From: [Symons, Brian D](#)
To: [Sager, John E - DNR](#)
Cc: [Gregory Prom \(MP\)](#); [Jamie Mehle \(SWLP\)](#); [Hughes, Erin](#); [Laszewski, Steve](#); [Saari, Christopher A - DNR](#)
Subject: RE: [EXTERNAL MAIL] SWL&P 100% Design
Date: Wednesday, December 28, 2022 5:16:49 PM
Attachments: [Attachments.html](#)

In the 90% Upland RAD comments, DNR requested nested piezometers with monitoring wells MW-3R and MW-4R and an additional monitoring well located near the City of Superior building in the area of SLIF-33. This e-mail is a response to DNR's e-mail dated December 27, 2022 regarding the nested monitoring wells and MW-29.

**UPLAND AREA REMEDIAL ACTION
 DESIGN DRAWINGS
 FOR THE
 FORMER MGP SITE**
SUPERIOR WATER, LIGHT & POWER
 WISCONSIN
 DOUGLAS COUNTY

AIR MONITORING STATION LOCATIONS

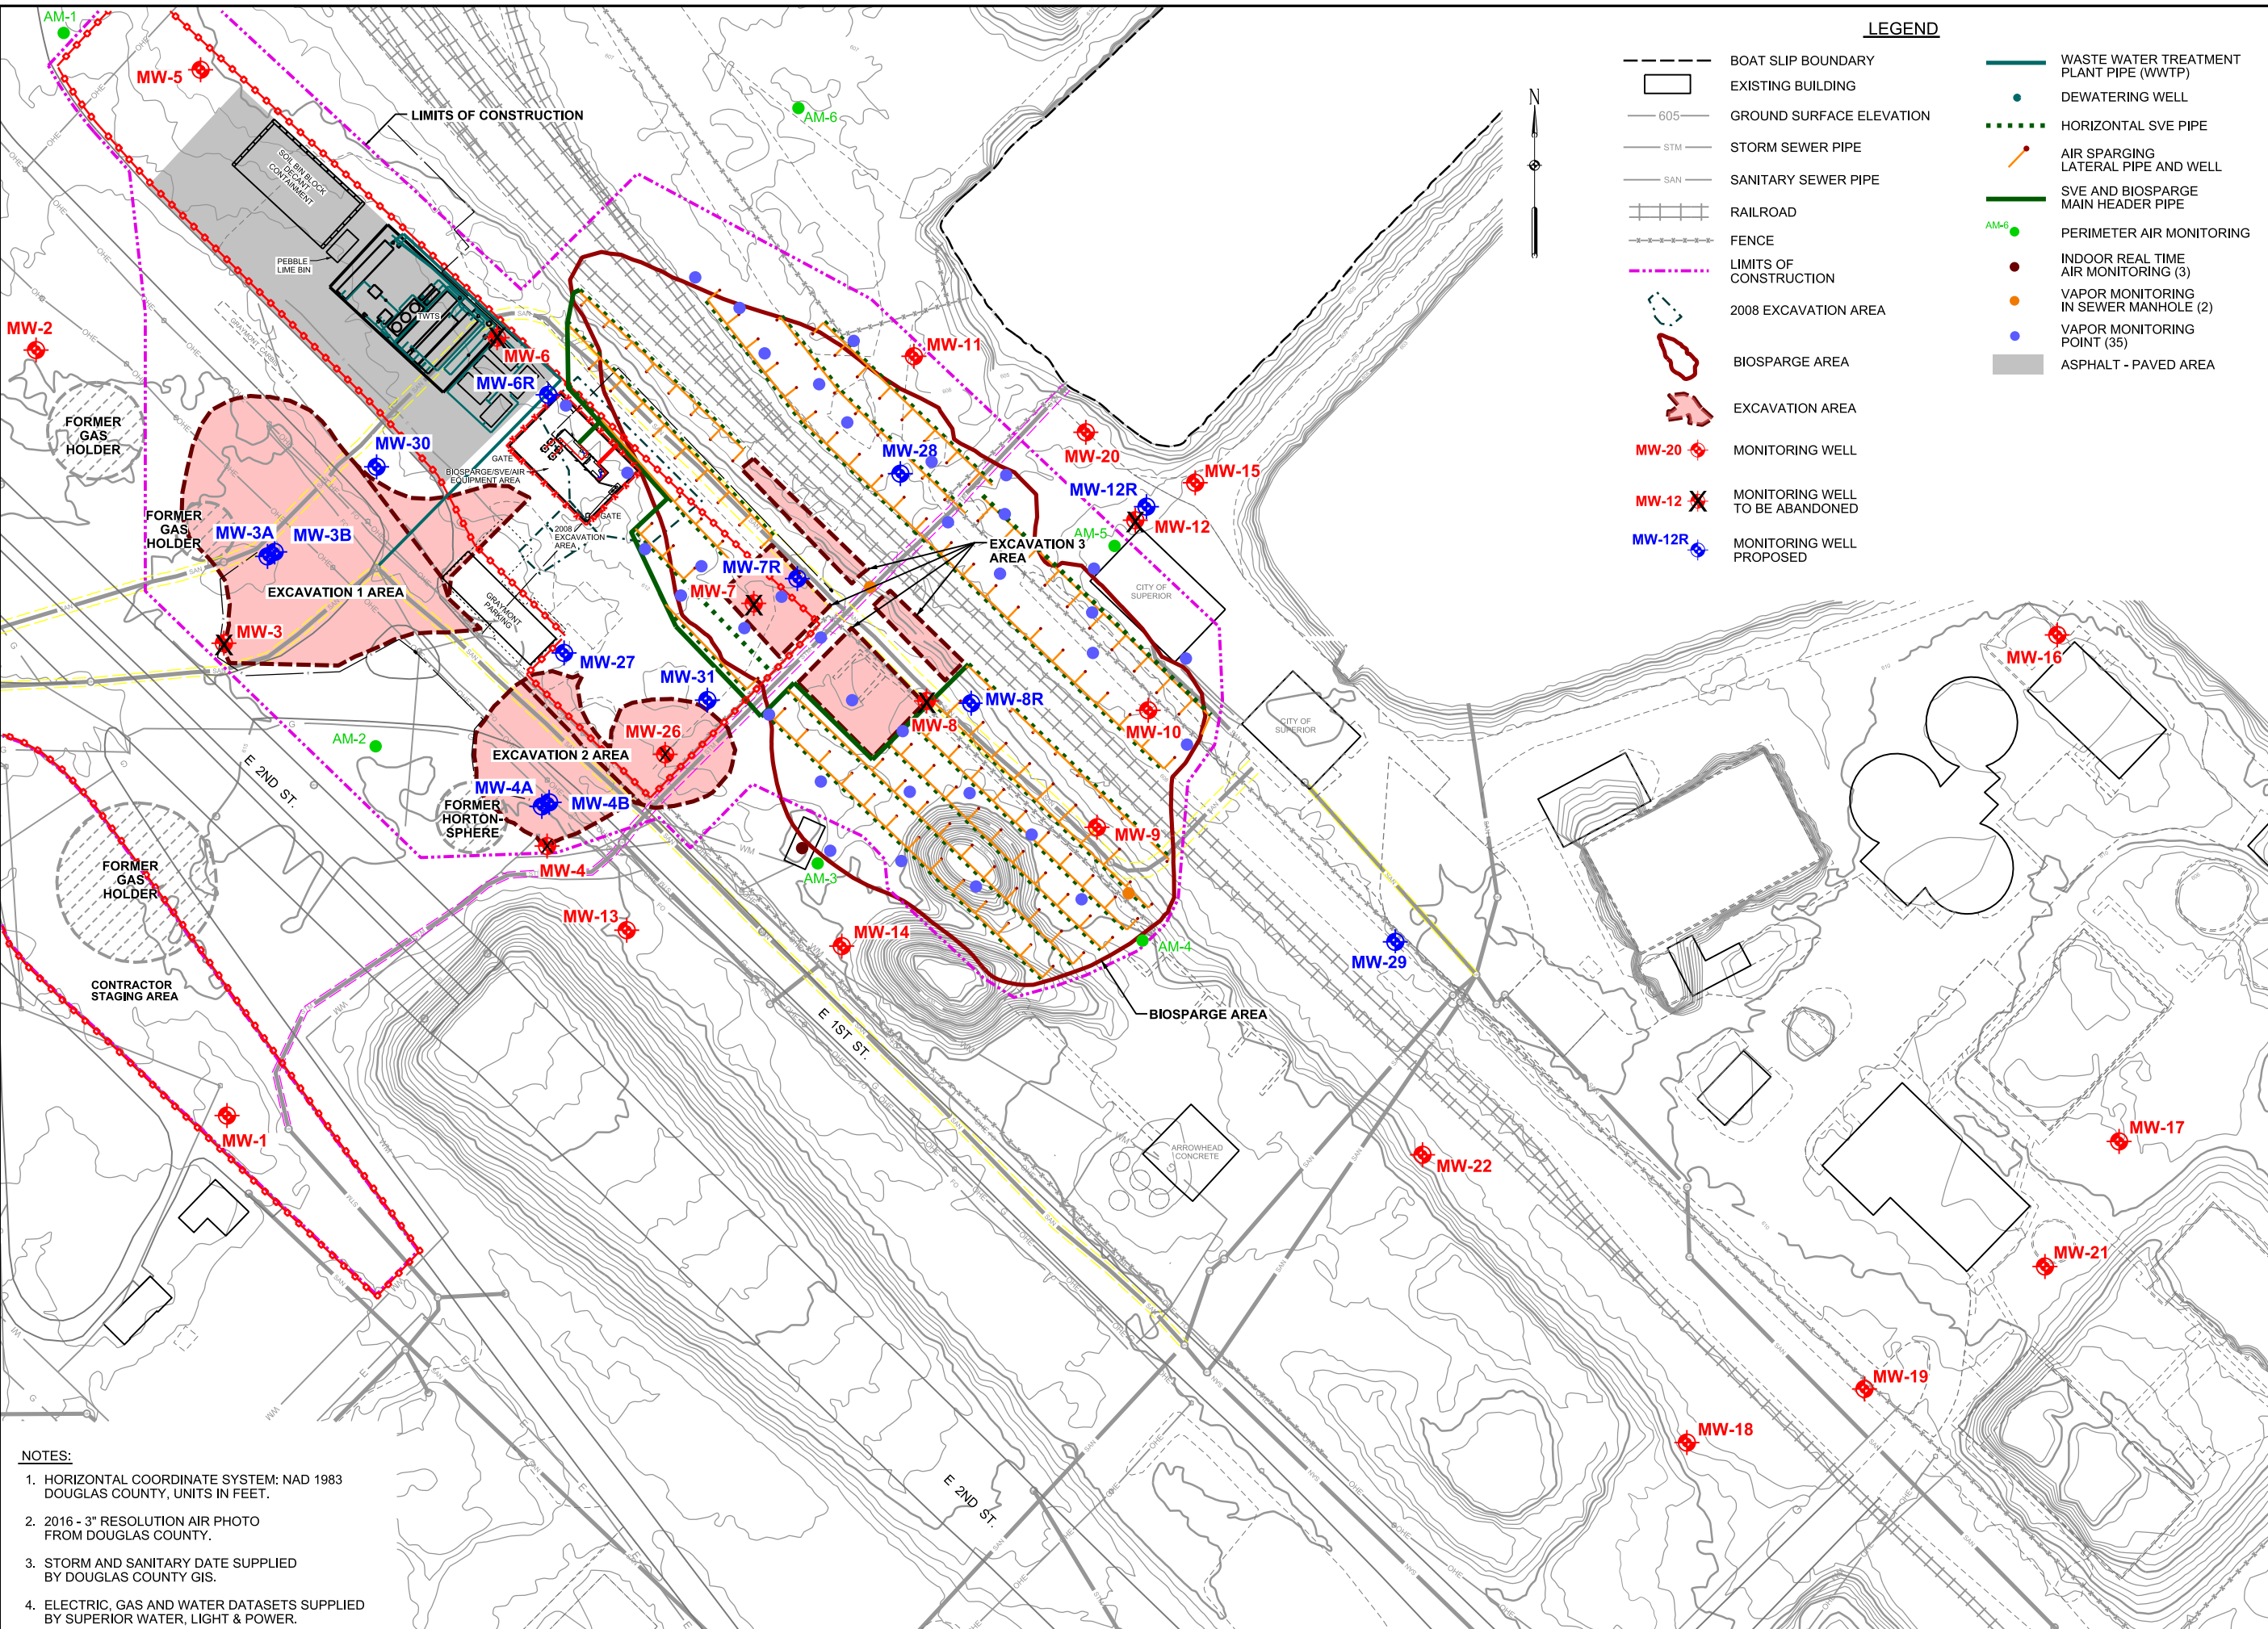
Also, Foth depicts the location of an additional monitoring well MW-29, further east than the DNR would prefer. The DNR wants a well installed near the location of SLIF-33 to be nearer the active remedial action area to be able to assess groundwater quality near the active remedial action system. Install the well screen to intersect the depths of elevated LIF values.

- the cross-sections for MW-3B or MW-4B screened between 596 and 601 ft MSL (i.e., Drawings B-5 and B-6 in the RAD, ECSWMP, and OM&M Plan) and
- the location for B-29 near SLIF-33 (i.e., Drawing A-8 in the RAD, ECSWMP, and OM&M Plan; FSP Figure 4-1; and AMP Figure 2-1).

GROUNDWATER AND AIR MONITORING LOCATIONS

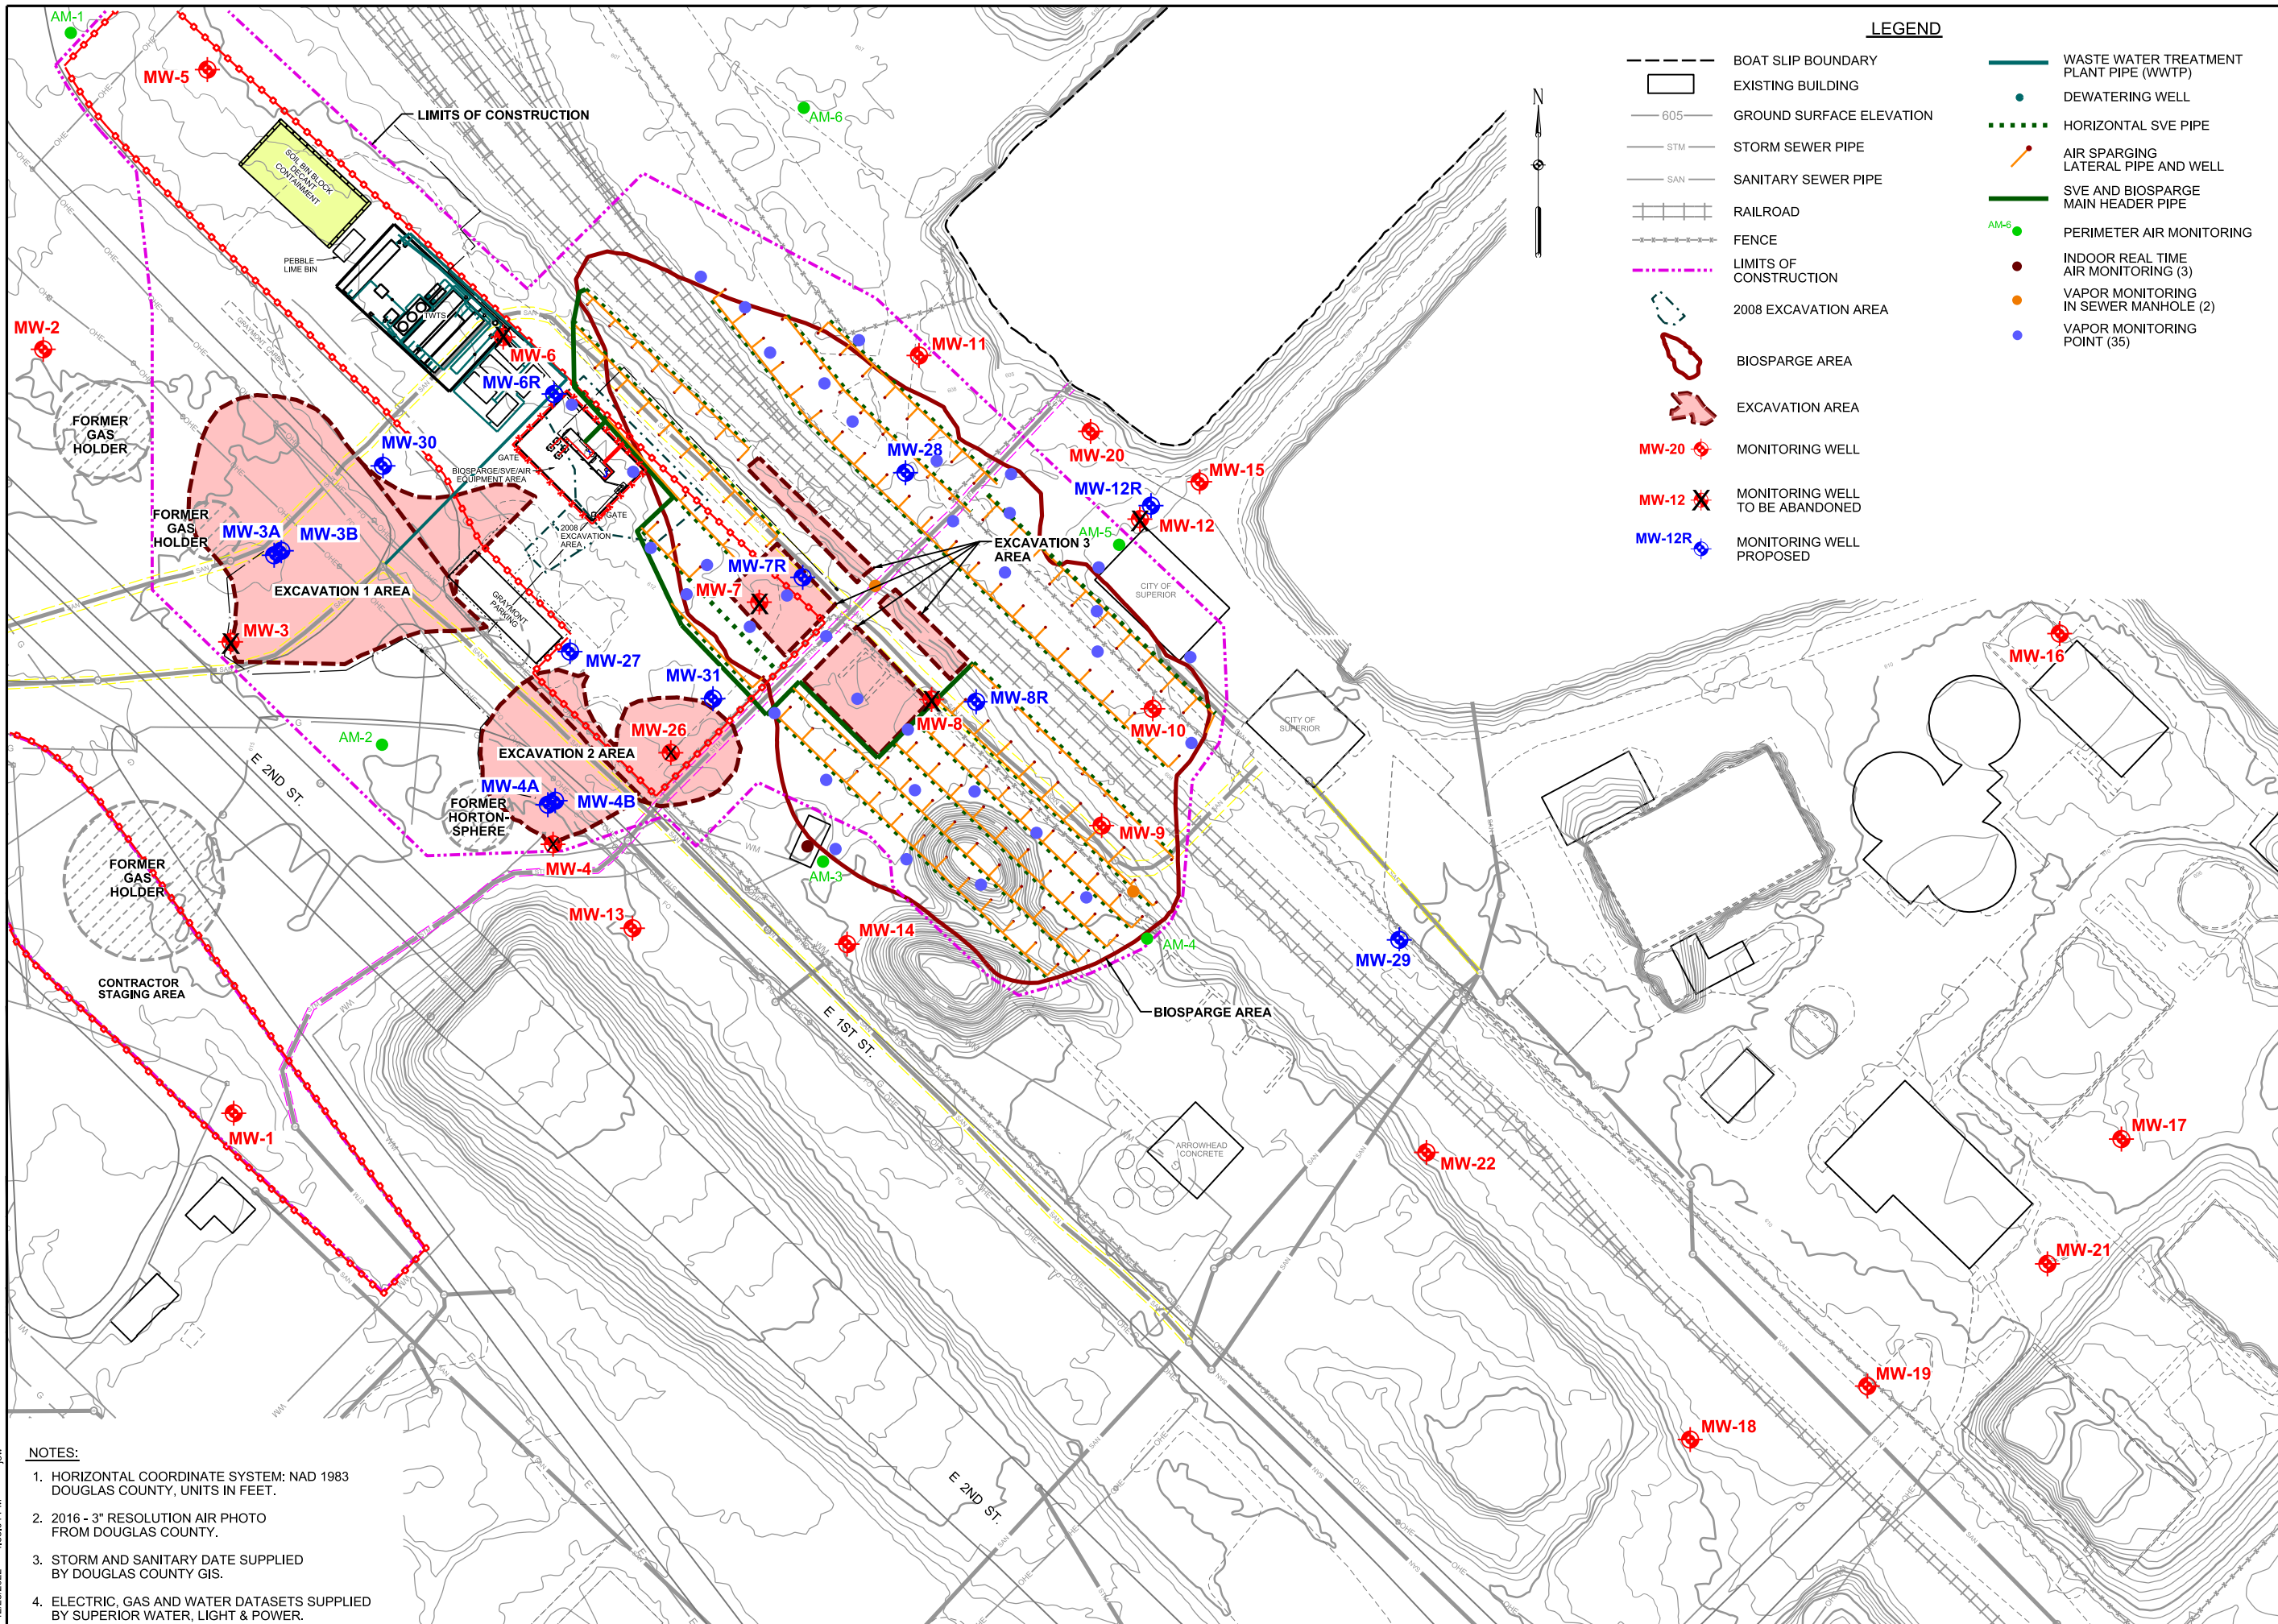
Figure 4-1 in Foth's Field sampling plan depicts the well in the same location as in the 90% design. Rather than delaying approval of the entire 100% design over this issue I would like written confirmation from SWL&P and Foth including a new Figure 4-1 depicting the locations

of the proposed monitoring well MW-29 in the location requested by DNR. If SWL&P and Foth would like to retain the location depicted then the DNR requests an additional monitoring well near the location of SLIF-33. If this issue is not addressed it may delay DNR issuing approval of the 100% design report.

The revised drawings are attached along with the Appendix B-1 drawing that shows the location of B-33 near the new location of MW-29.

**CROSS-SECTIONS
 FORMER MGP
 GAS HOLDER**

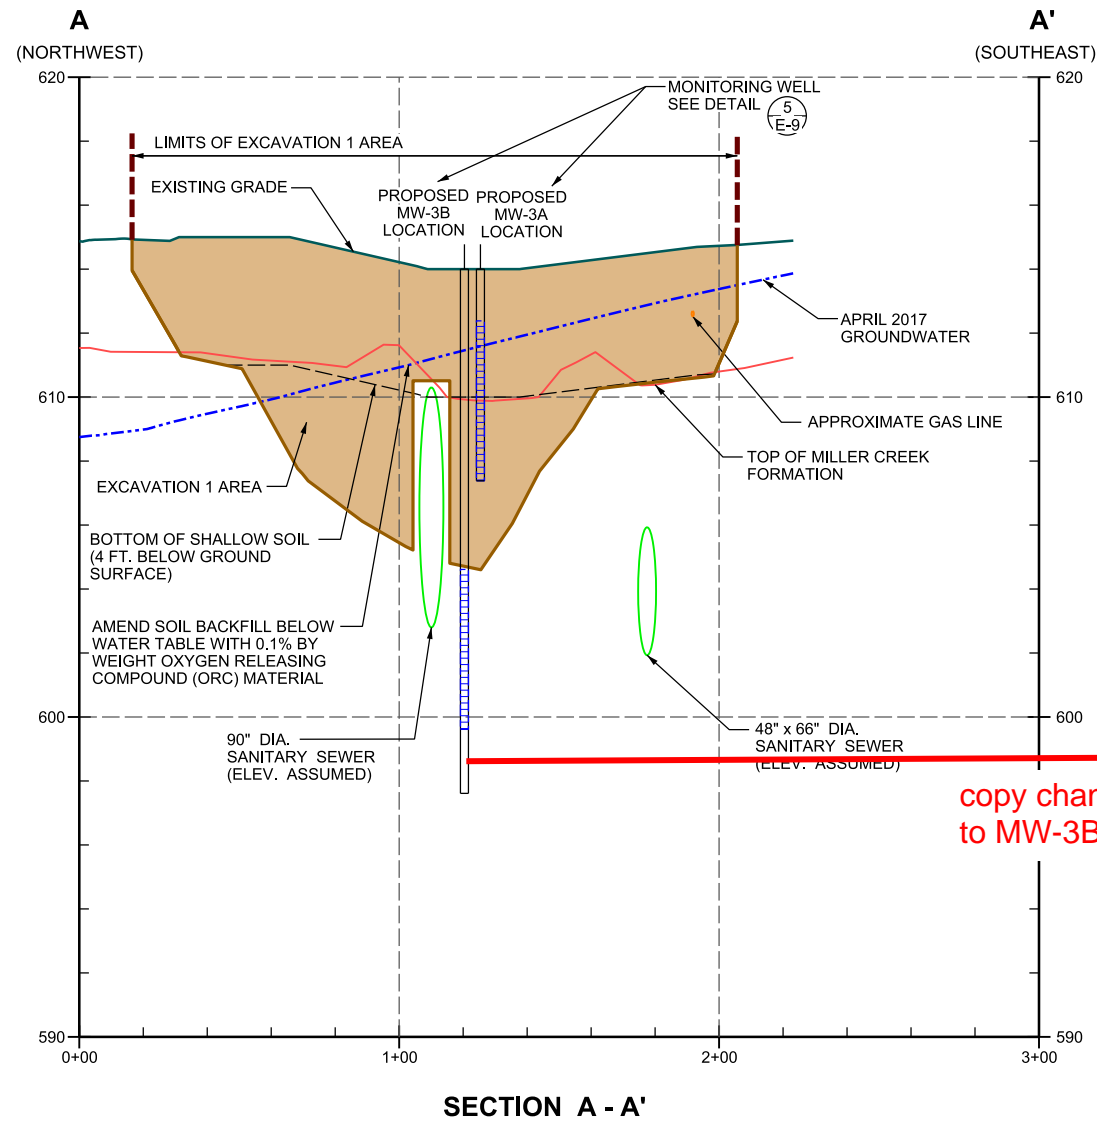
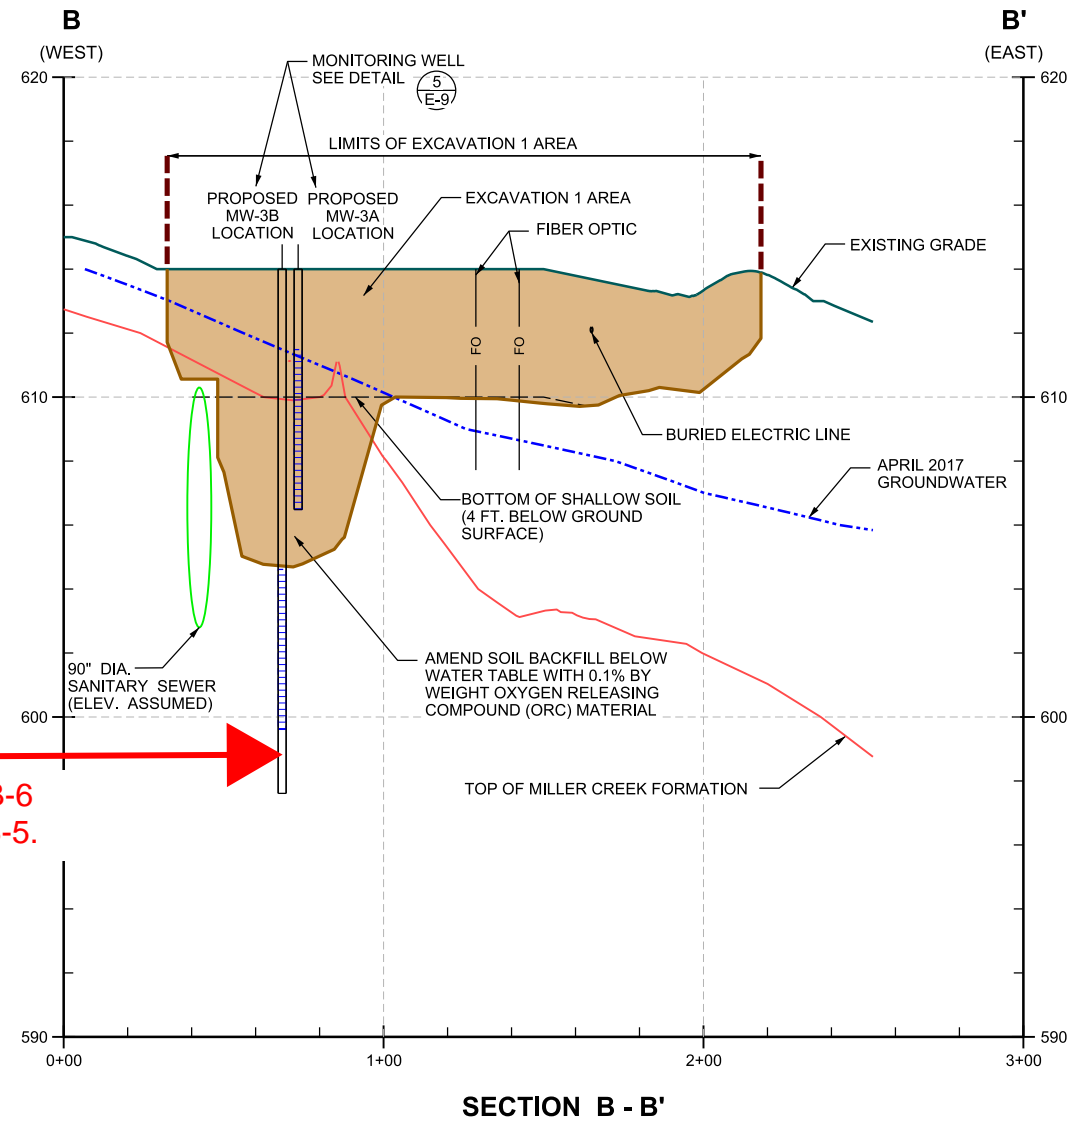
- the screened interval for MW-3B and MW-4B to be installed at approximately 596 to 601ft MSL adjusted to intersect sand layers, if present, and
- the location of MW-29 to be located further west near SLIF-33.

copy changes for MW-4B from B-6 to MW-3B on both sections on B-5.

The changed figures look good except I am a little confused about Figure B-5 and B-6. They appear to be draft figures with notes for changes, not final figures (see below). The modifications look correct but please send me the final figures when they are available. Thank you.
